A G E N D A

Architectural Review Board

June 28, 2022 – 5:30 p.m.

6C

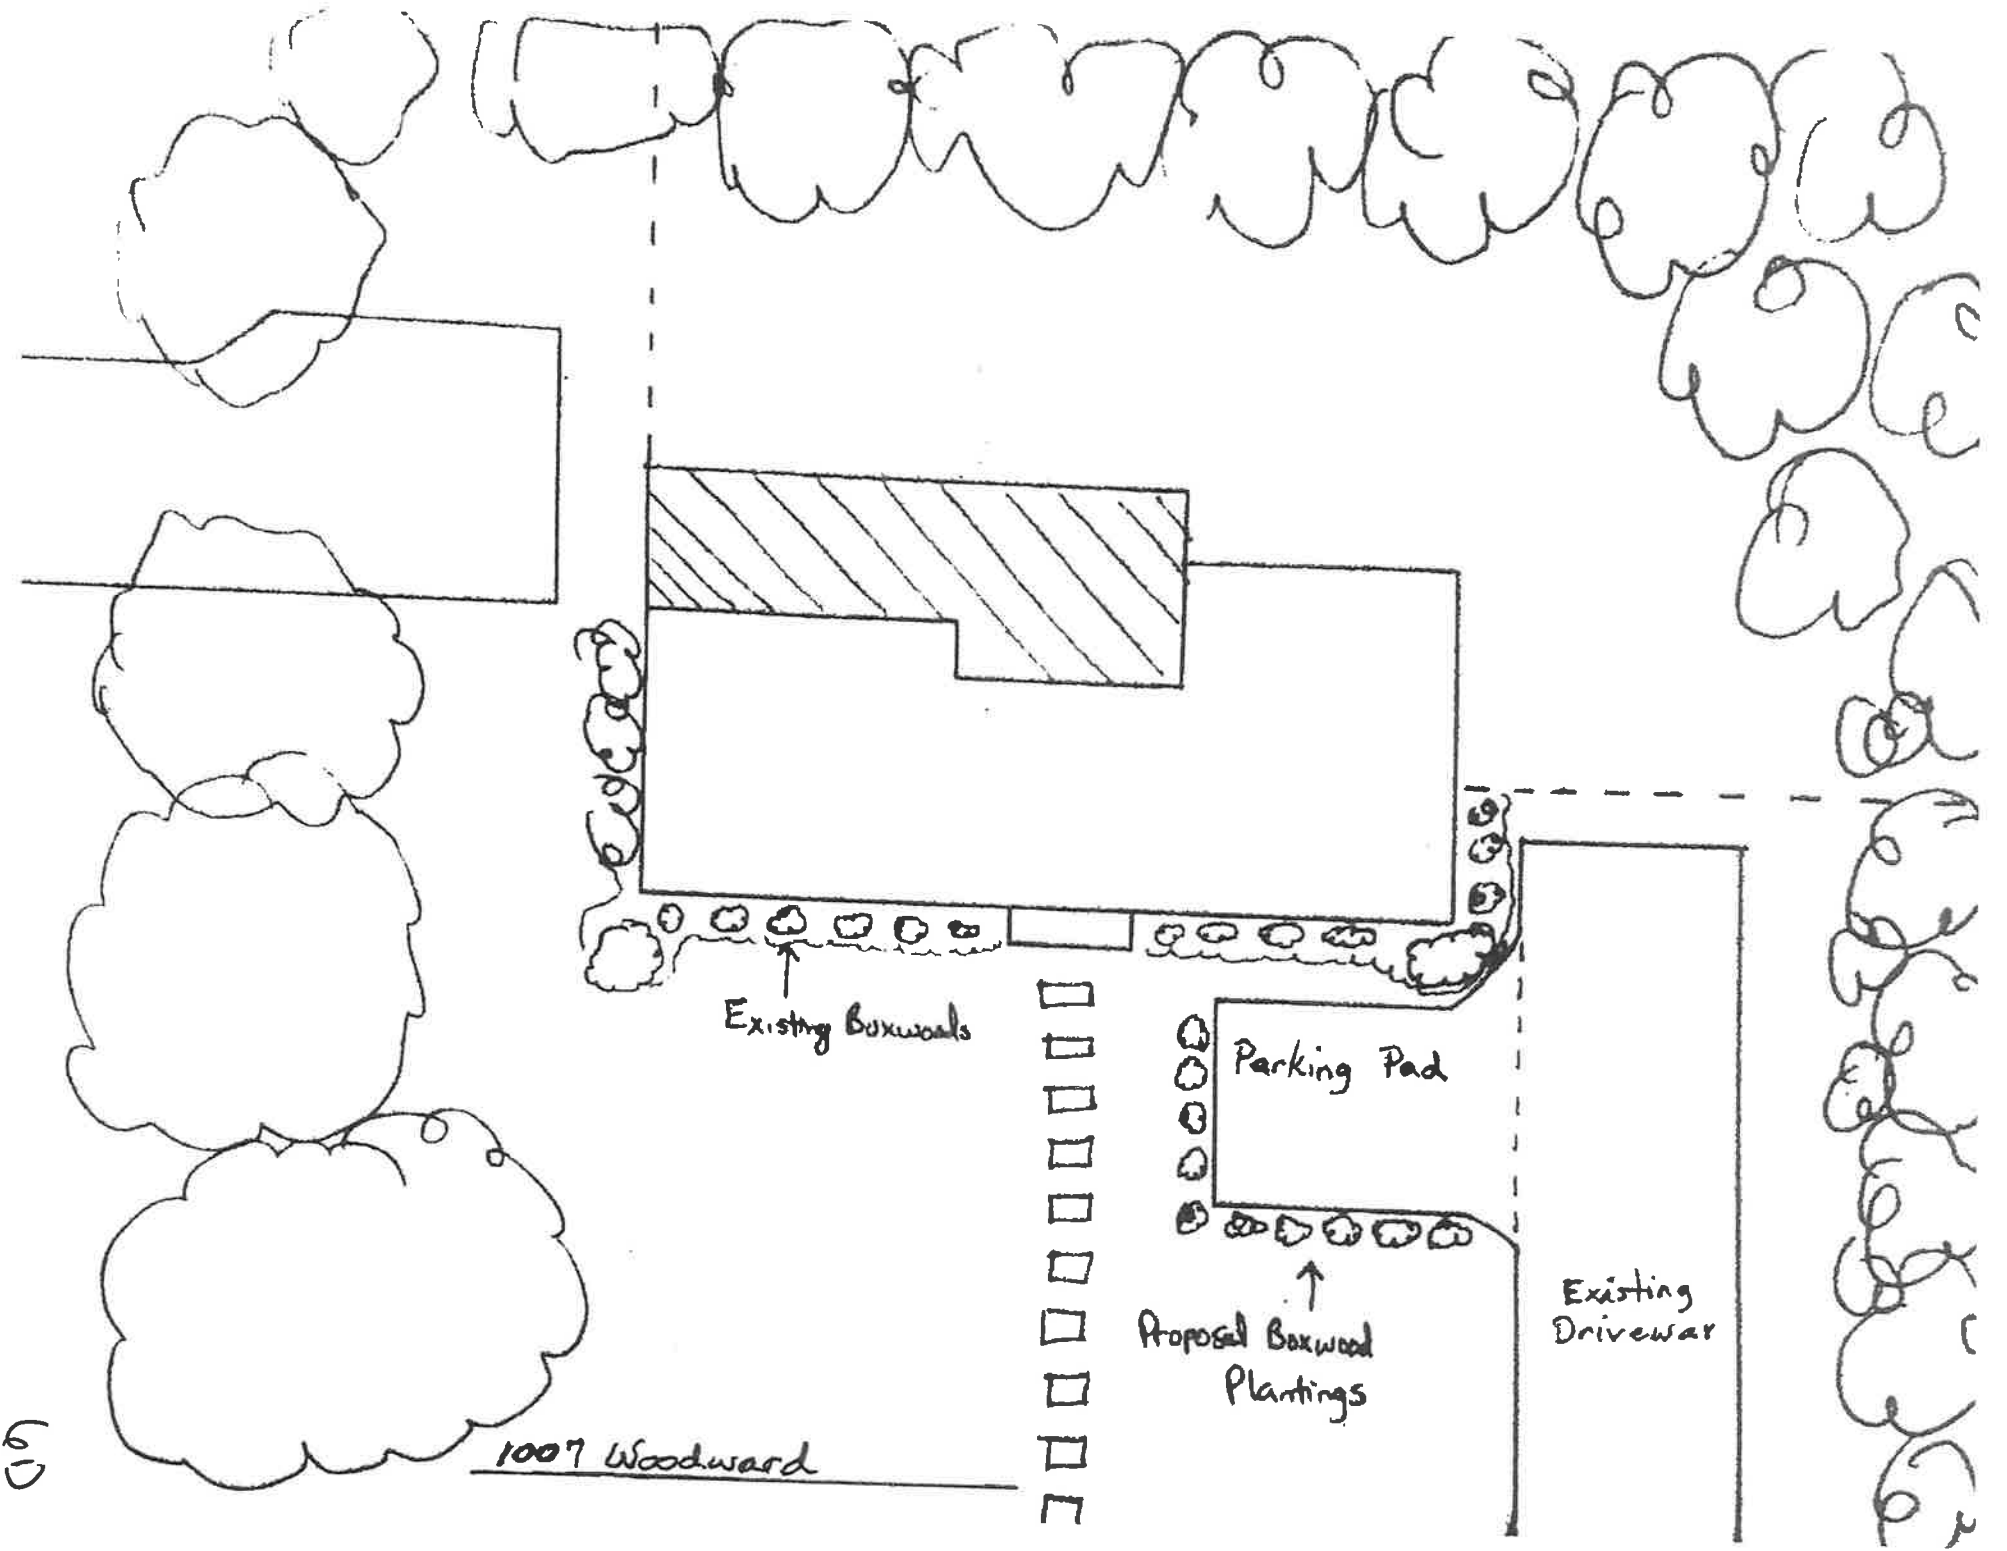
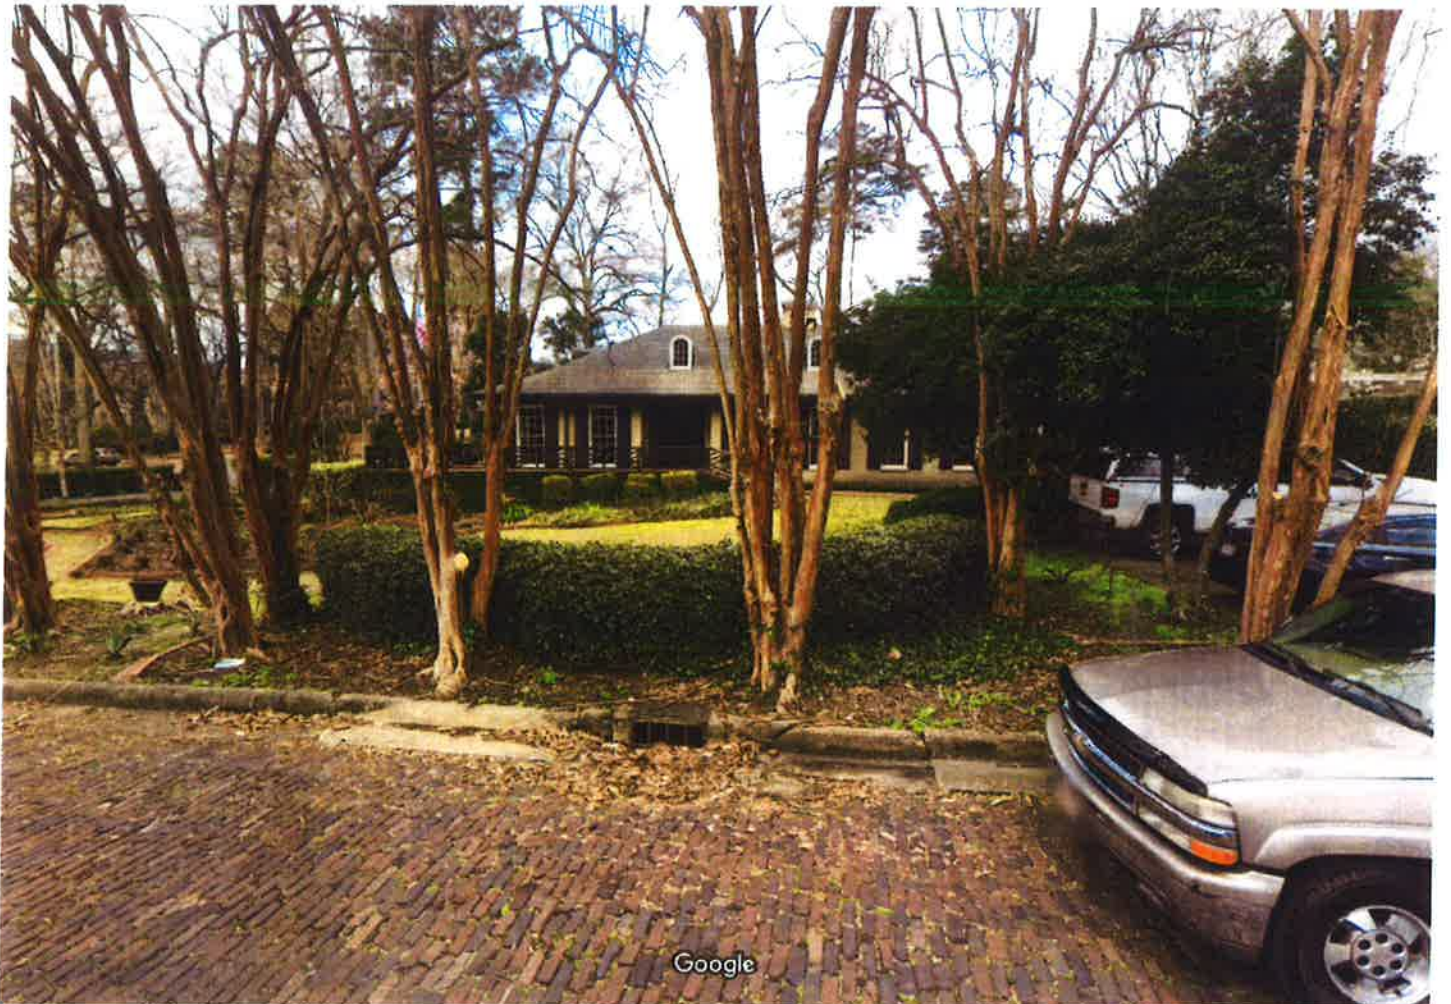
- The question for the Board with violations is always “Would we have approved this project as presented if the petitioner had asked first?” Just because it is there doesn’t mean it has to stay there as is.

- The situation is always evaluated on a case by case basis as well as considering whether a differently executed plan would yield a similar result. It would be a tight fit, but there is just enough space that two cars might be able to fit side by side next to the house without encroaching in front of the house. There is also an existing parking/drive area off of E. Cloverdale Park that has potential to be expanded or relocated to have less visual impact on the house.

- Several photos of nearby examples of front parking areas have been submitted. At least one of those was there prior to designation, one property has no rear access, one house is significantly elevated above grade, and one is a long house where the parking is away from the main block of the house (see map). Petitions are evaluated on a case by case basis taking into account the peculiarities of each property.

- Landscape screening has required evergreen shrubs, at least 18” high at installation, spaced 36” on center.

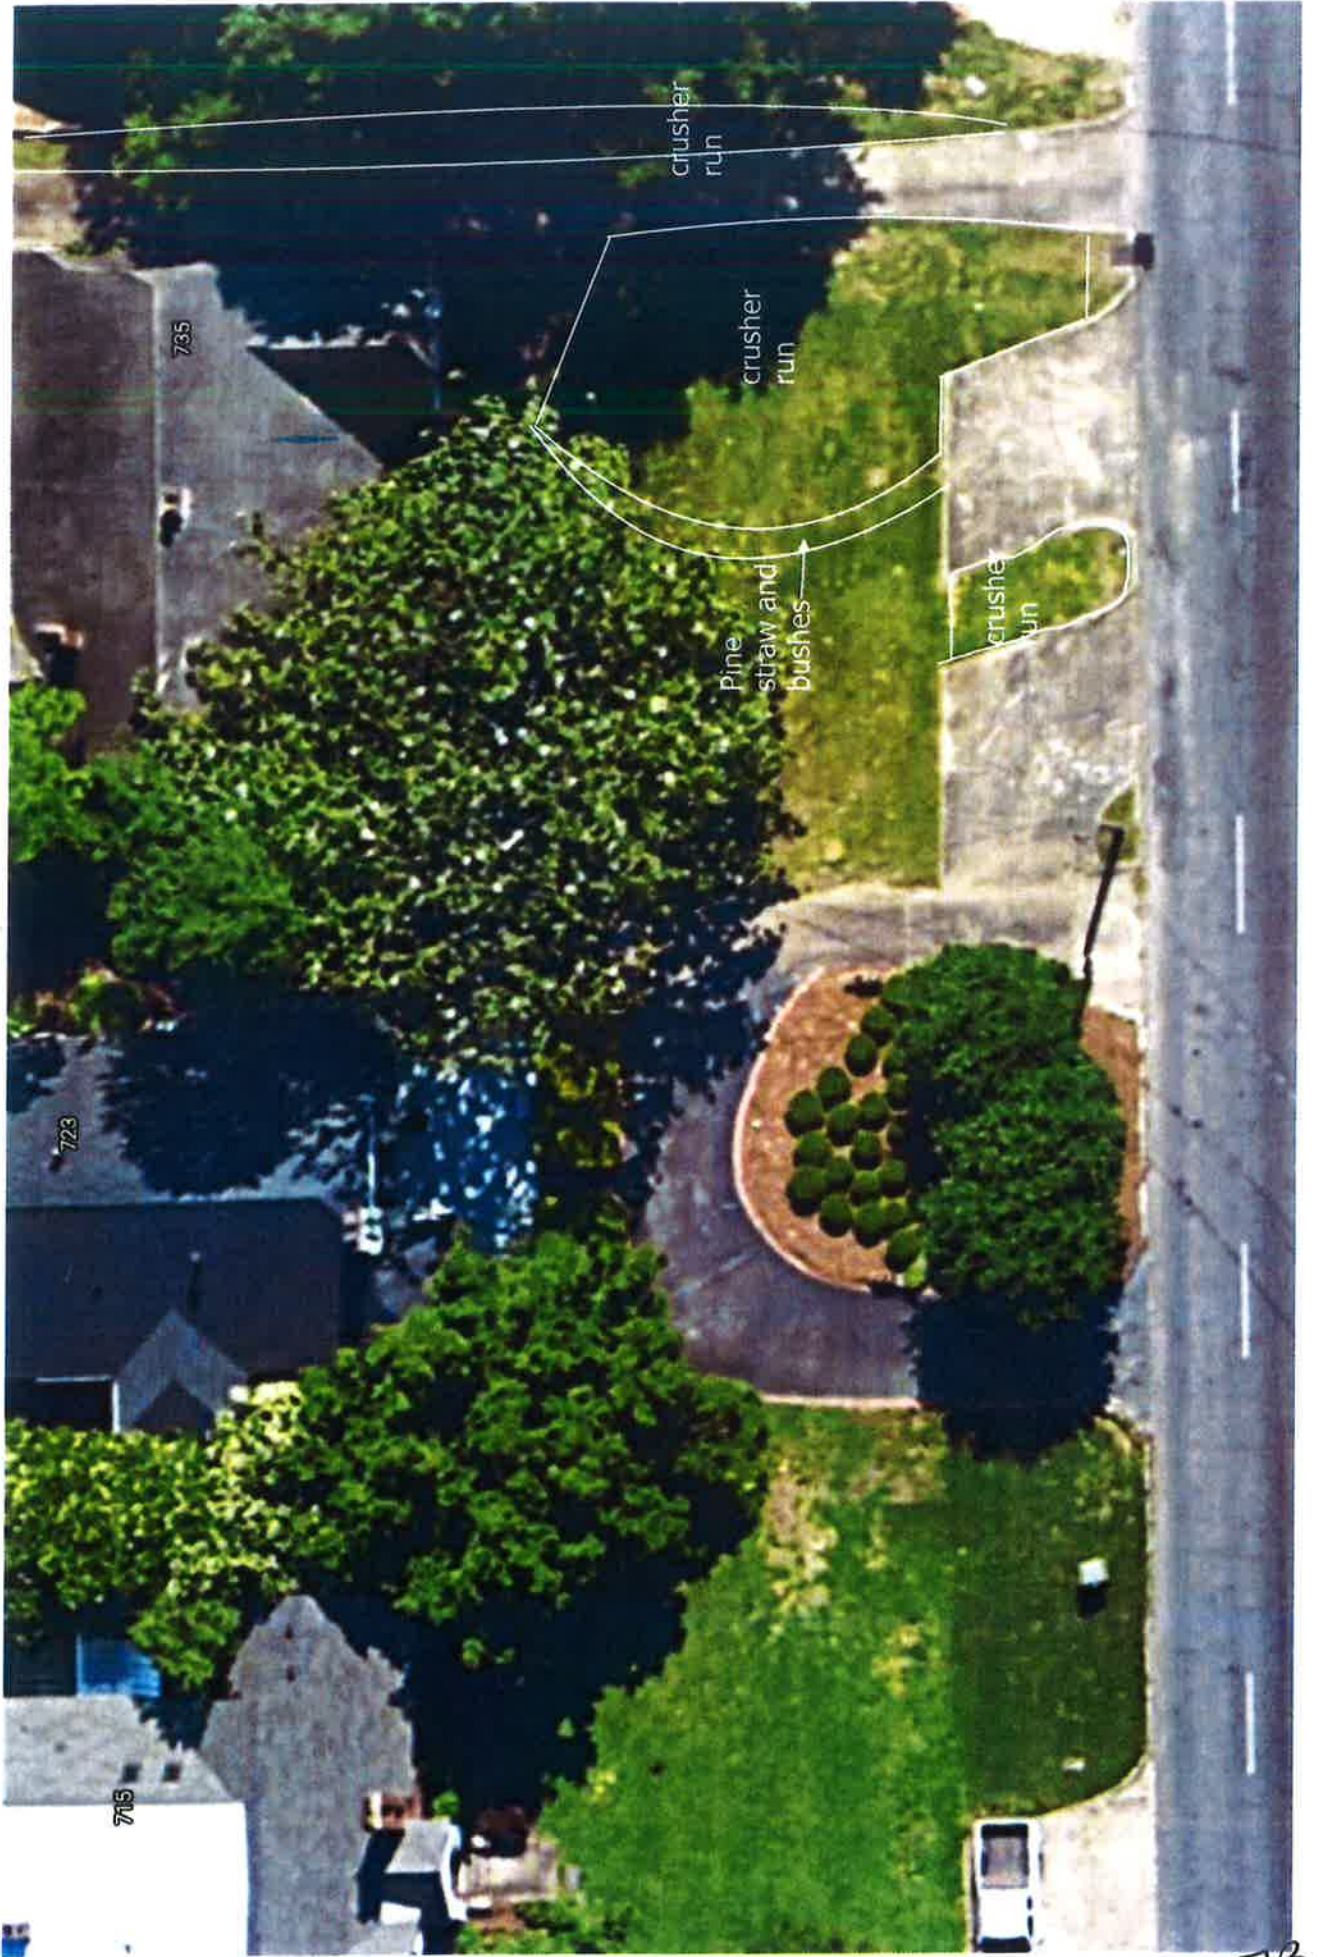
- The question for the Board with violations is always “Would we have approved this project as presented if the petitioner had asked first?” Just because it is there doesn’t mean it has to stay there as is.

- The situation is always evaluated on a case by case basis as well as considering whether a differently executed plan would yield a similar result. This property has a driveway that goes behind the house to a garage, which offers some off street parking.

- The parking area directly abuts the front walkway to the drive and appears to be 3-4 cars wide (dimensions were not provided) including the driveway. This should be pulled out of the visual line of site to the front door.

- Parking area encroaches in front of the front door, which is nearly half the width of the house
- Gravel should be clearly contained so it cannot spill into the street.

- When parking areas have been approved, they had to be able to provide enough screening from the street to soften the view of the parking area from the street. Parking area, if approved, should have a screen planted along the Fairview edge of the property and not present a continuous sea of gravel on the east half of the front lawn to the front property line. That will still afford the opportunity to not have to back out onto Fairview. Installed landscaping does not appear to meet the landscaping guidelines of evergreen shrubs, 18” high at installation, spaced 36” on center.

- Gravel added to the side of the driveway also appears to lack containment on the slope to prevent washing into the street. Should gravel be approved in this location as a fill for the concrete? Or should concrete be repaired with concrete or removed and entirely replaced with gravel?
